CITY OF ALBUQUERQUE
PUBLIC WORKS DEPARTMENT
UTILITY DEVELOPMENT DIVISION/HYDROLOGY SECTION

SUBJECT: United NM Bank

RE: REVISED DRAINAGE PLAN FOR UNITED NEW MEXICO
(K-16/D42) REVISION DATED APRIL 17, 1992

PROJECT TITLE: UNITED NM BANK ZONE ATLAS/DRNG. FILE #: K16/D42

GRADING PLAN 1" = 20'

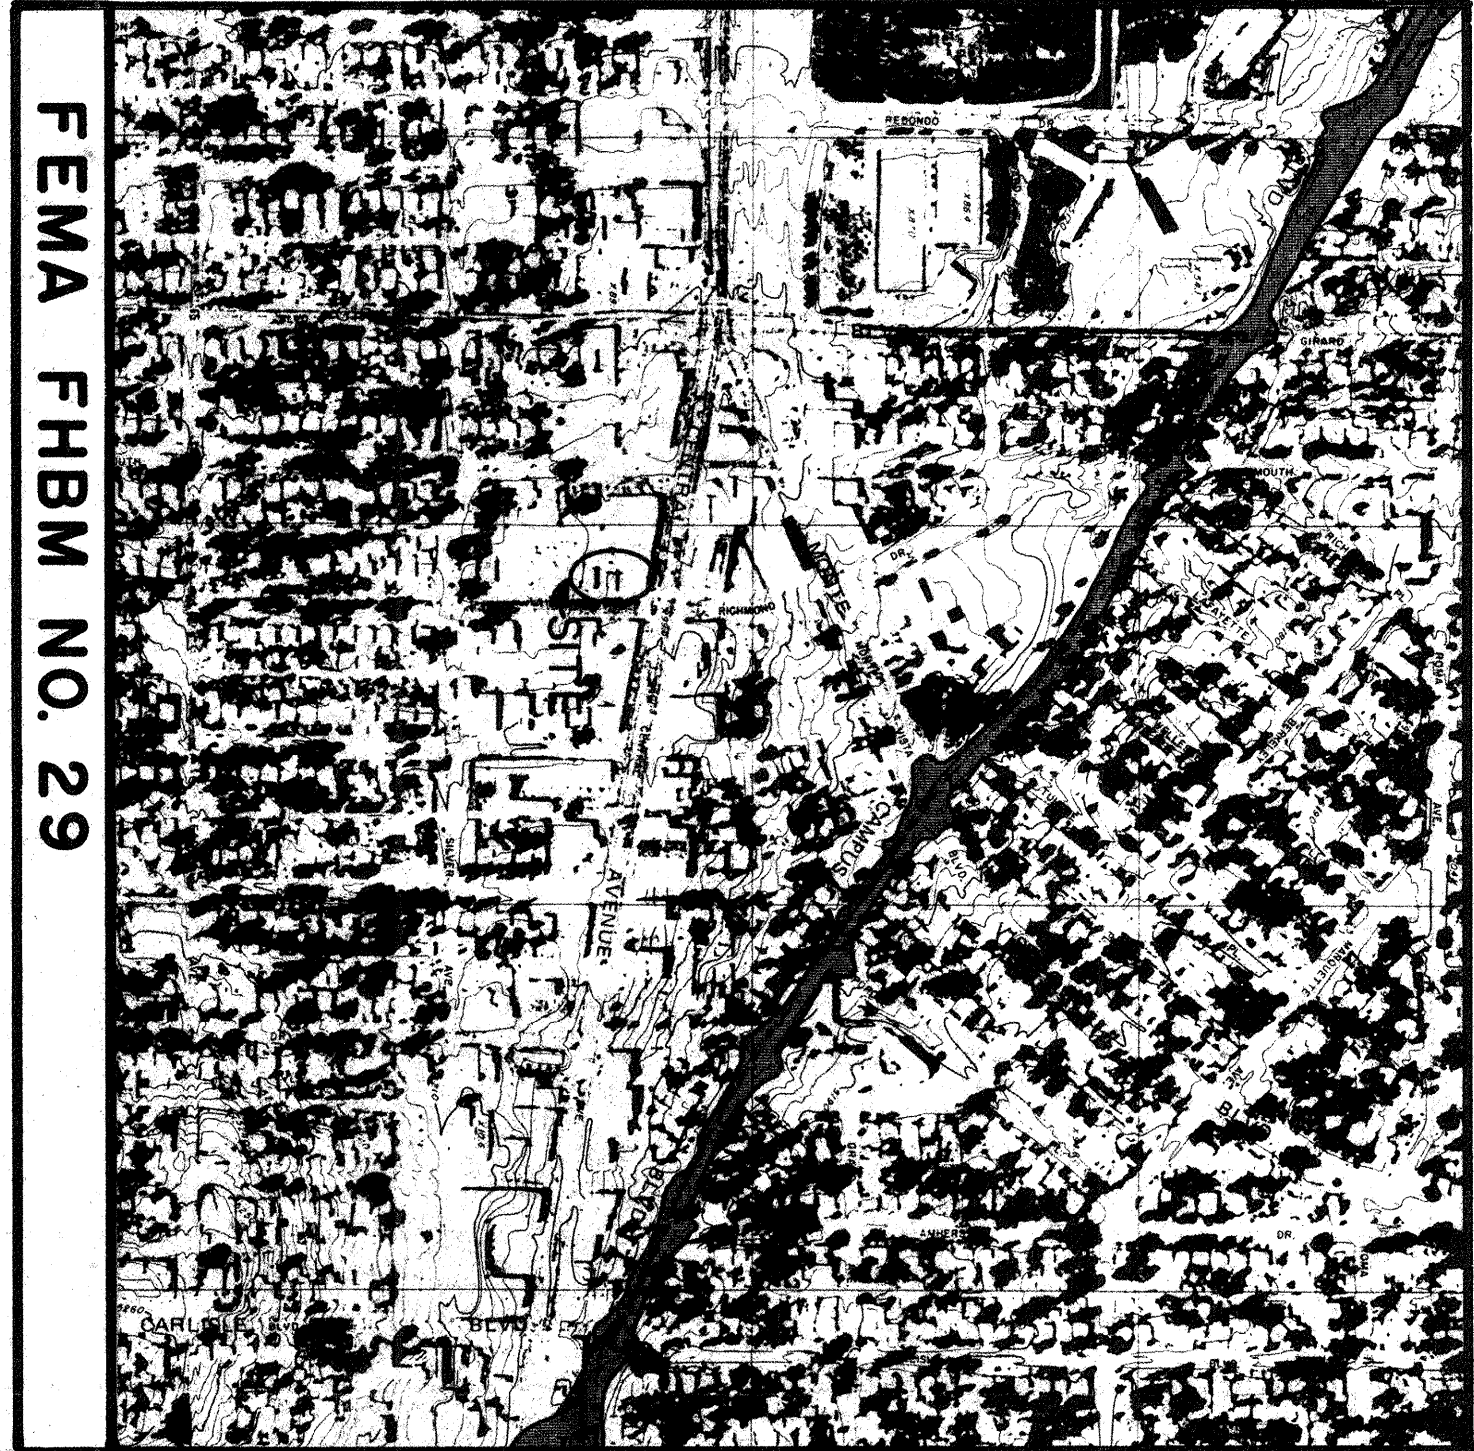
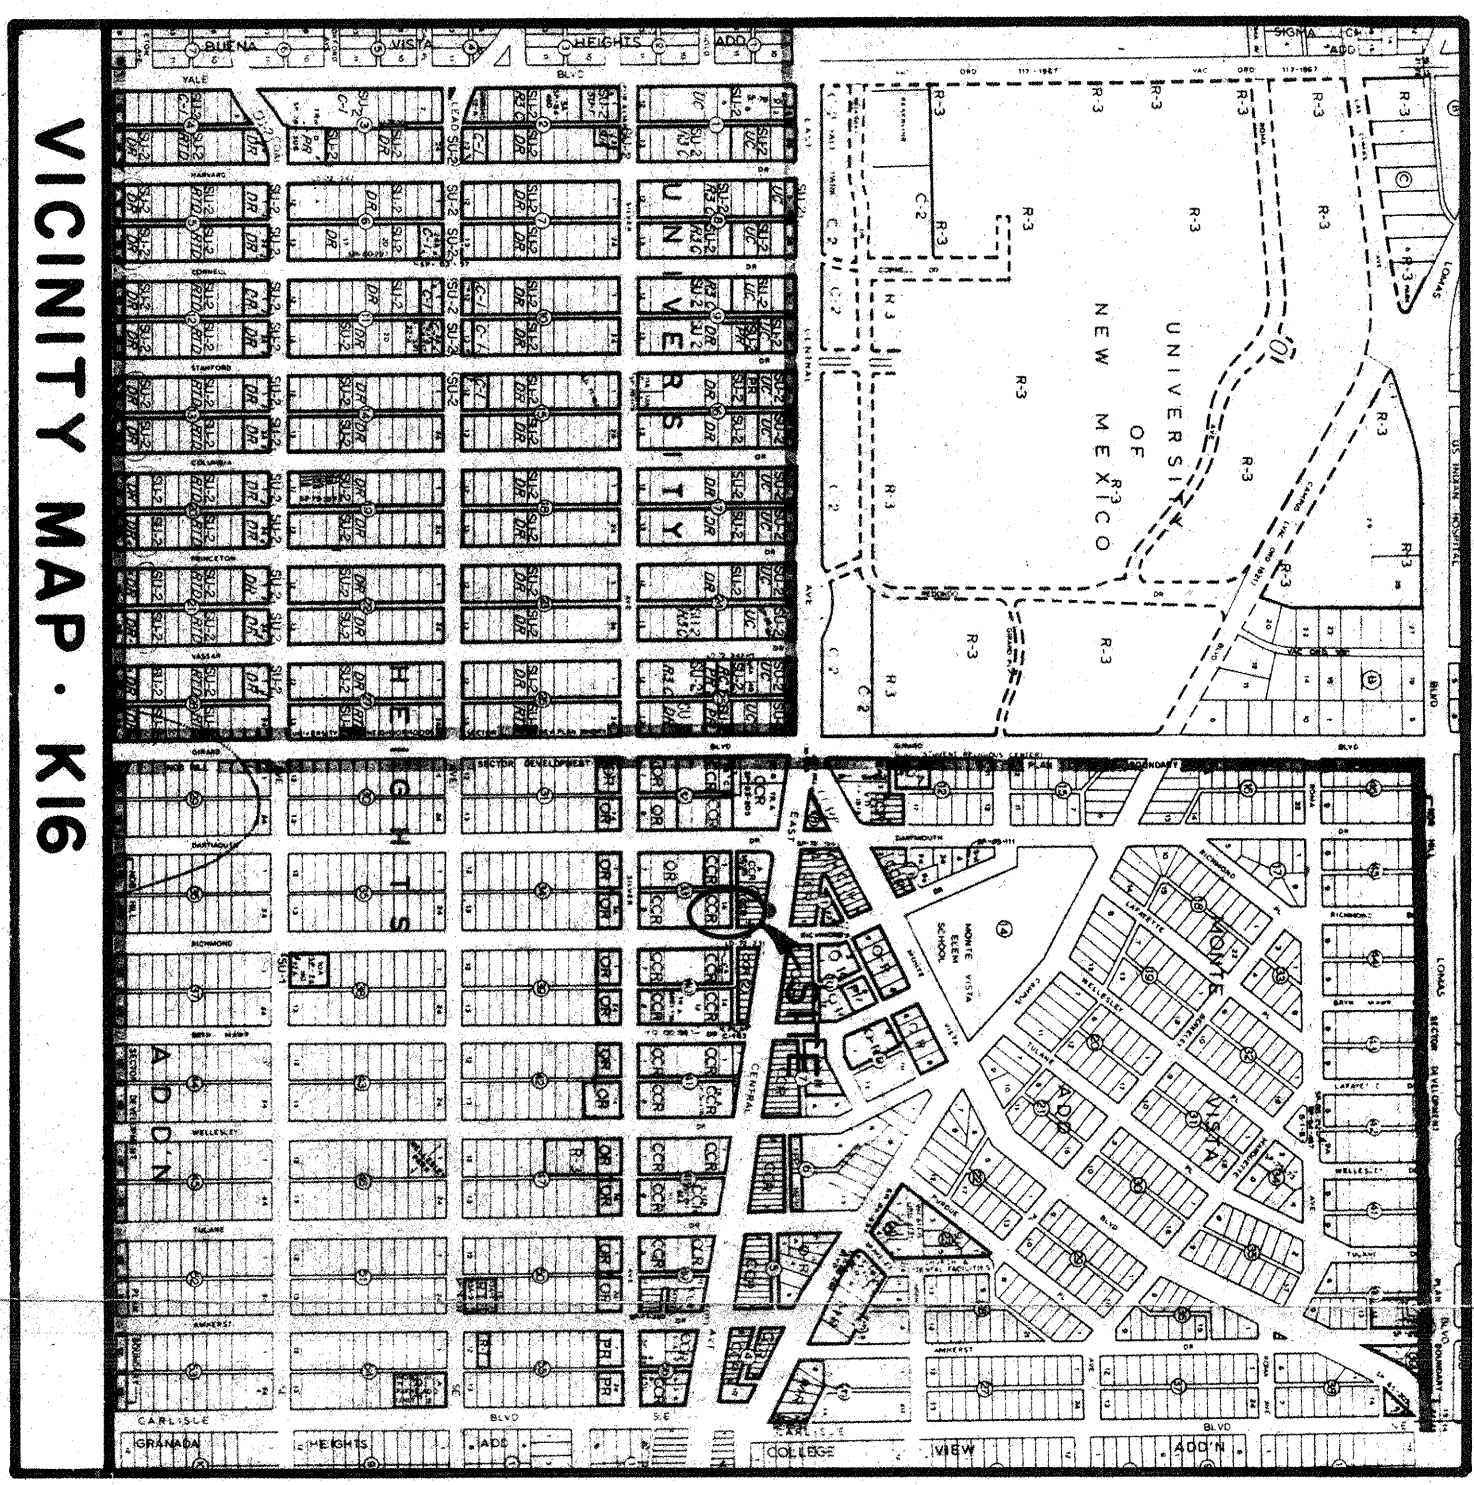
Based on the information provided on your submittal of April 17, 1992,
revisions as indicated are acceptable.

Please be advised that prior to Certificate of Occupancy release, we will need
Engineer's Certification of the grades that were required by Traffic
Engineering.
